Design Clarification No. 1

<b>Project:</b>	Avery County C&D Landfill Phase III - Cell 1 Construction Avery County, North Carolina
<b>Owner:</b>	Avery County Solid Waste Attn: Buddy Norris 175 Linville Street Newland, North Carolina 28657
<b>Contractor:</b>	Blue Ridge Grading & Trucking, Inc. ATTN: Ryan Holiman 20 E. US Hwy 19E Bypass Burnsville, North Carolina 28714

**Reference(s):**  
GCL Installation: Details 1/EC4 and 1/X1

1  
EC4

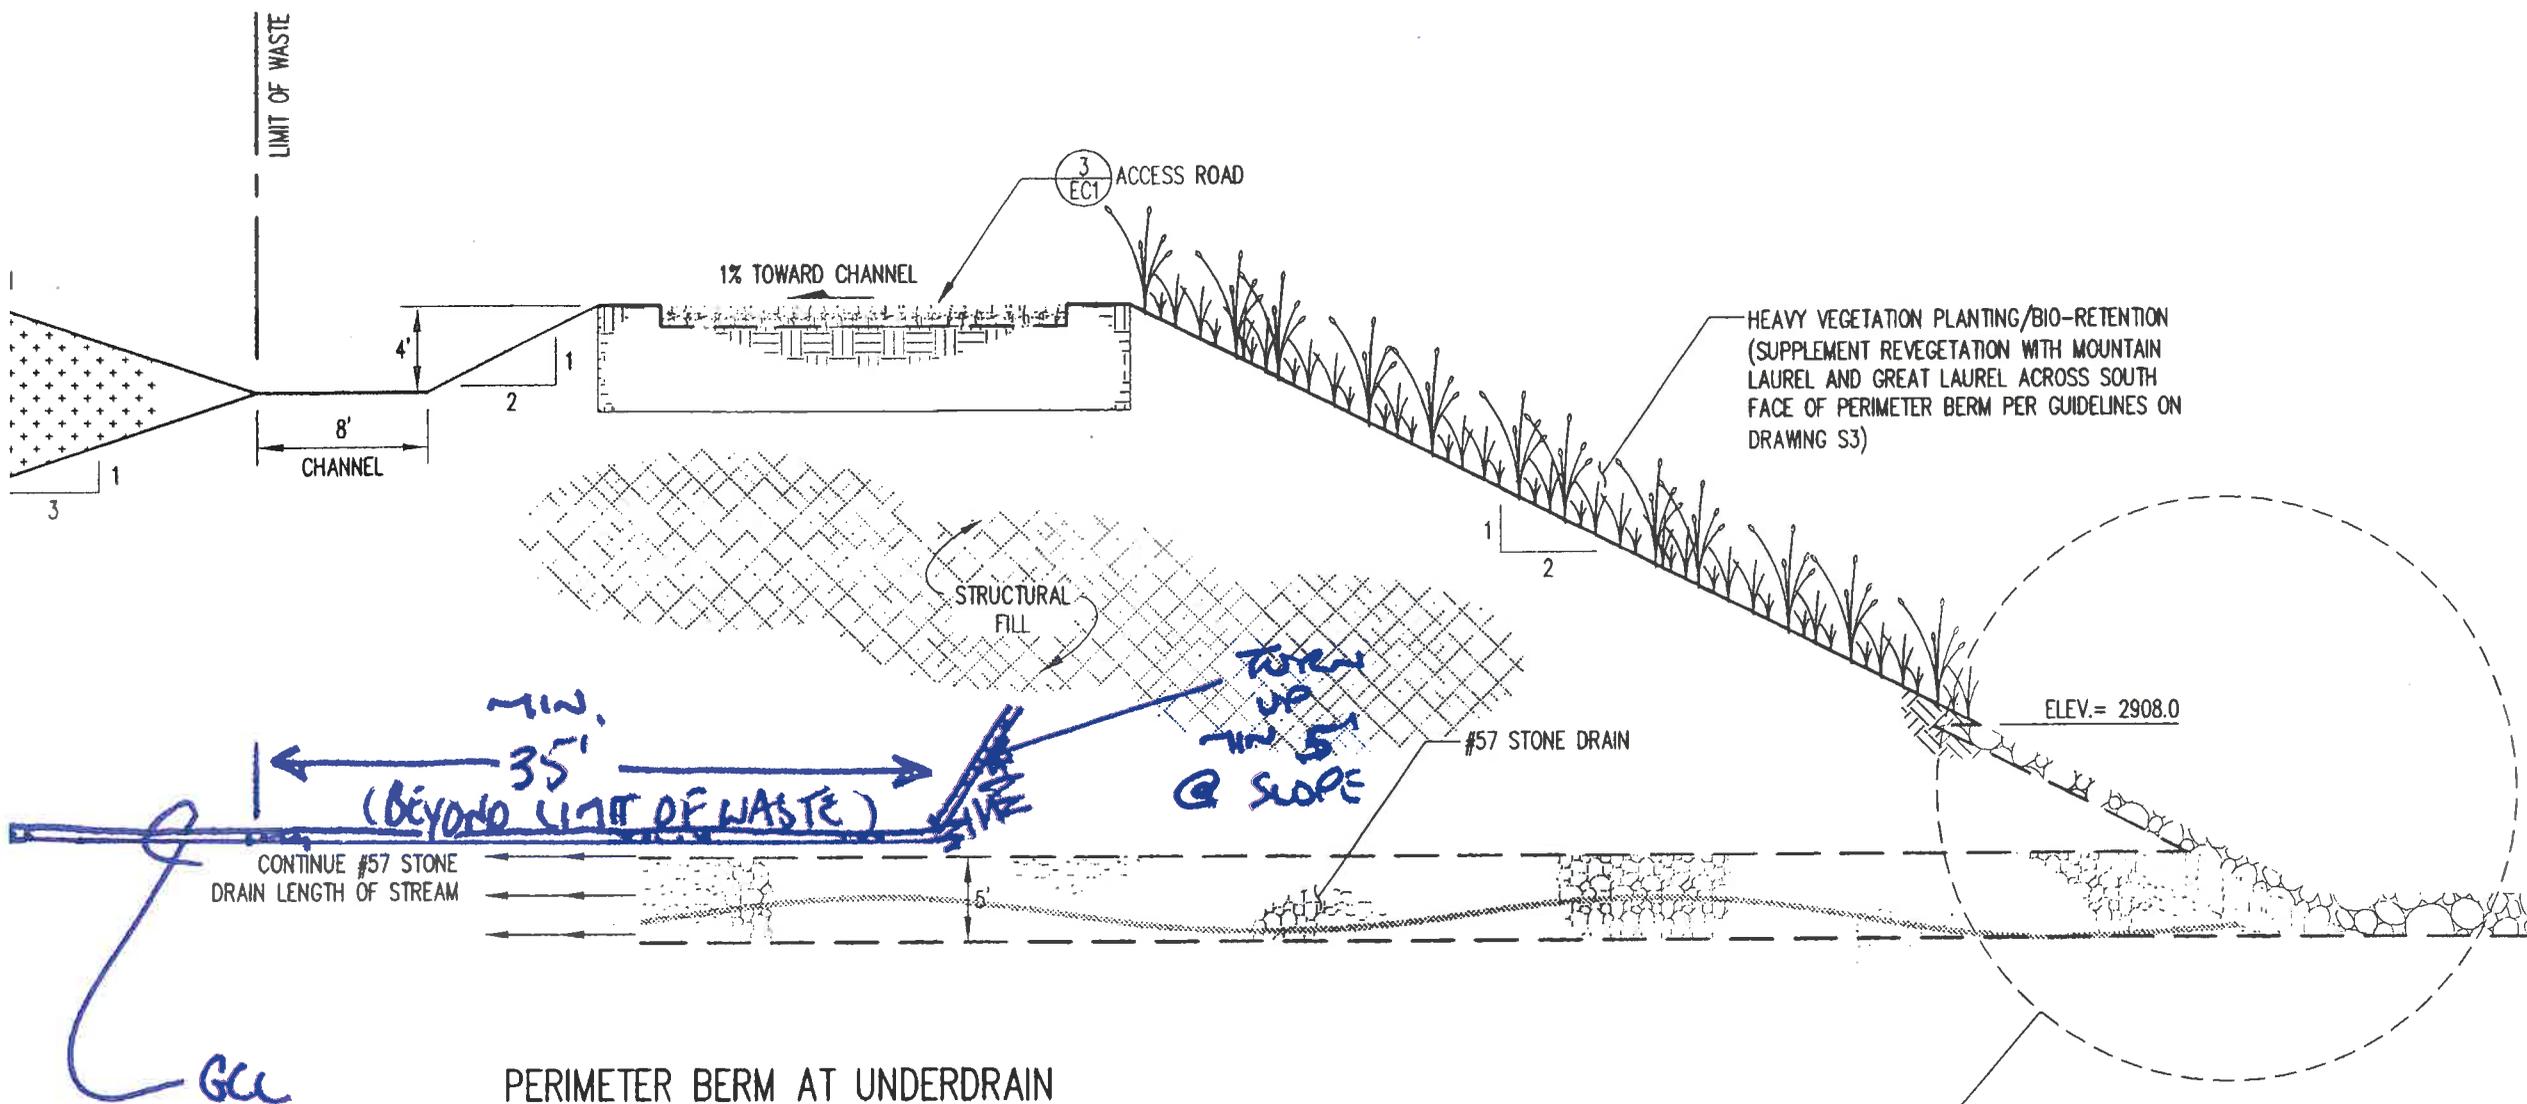
**Description of Clarification(s):**  
The GCL shall be installed a minimum of 35 feet beyond the proposed limits of waste as shown on the attached drawings and should be extended as far as south as feasible to maintain a 10 foot high berm for protection of downstream waters during construction.

**Reason for Clarification(s):**  
To facilitate construction, protect downstream waters, and to provide hydraulic barrier for the landfill, the installation of the GCL was reviewed with the existing conditions in mind. Therefore, the bulk of the underdrain can be installed and backfilled prior to the installation of the GCL, whereby, the GCL can be installed in a single mobilization.

MIN.  
35'  
(BEYOND LIMIT OF WASTE)

TURN  
UP  
MIN. 5'  
@ SLOPE
